1966 Corvette: Product Data Book: Radiator Grille Supports

Source: Technical Service Department - Product Data Book

Section: XIII, Group 2

Date: March 22, 1966

FIGURE 1

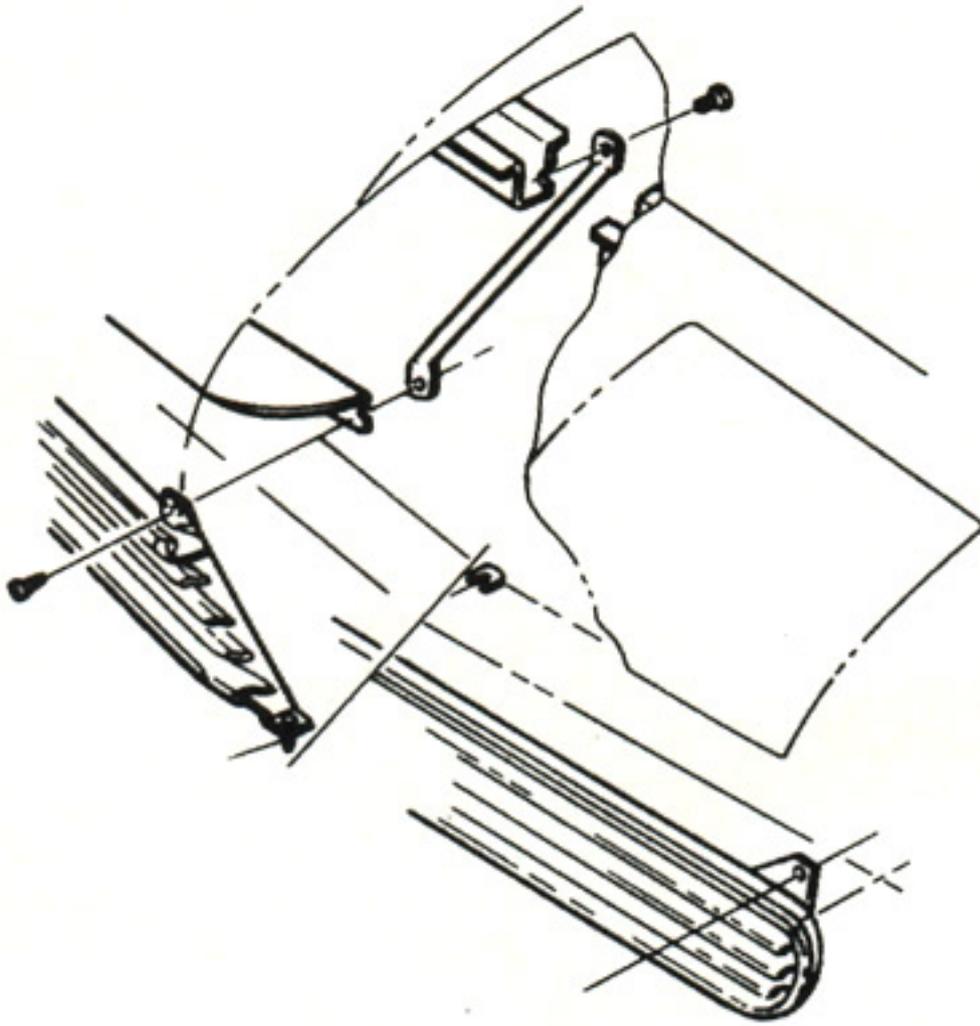
When 1966 Corvettes are driven on rough surface roads, there is a possibility the outer grille supports may break at the body attaching locations.

In production, starting with serial #S115499, the radiator grille supports are of an improved design and a radiator support rod has been added at the center. This is similar to 1965 production.

If outer grille support breakage is encountered on vehicles built prior to serial #S115499, install radiator grille supports, Part No. 3897389, and center radiator support rod, Part No. 3897387. (fig. 1).
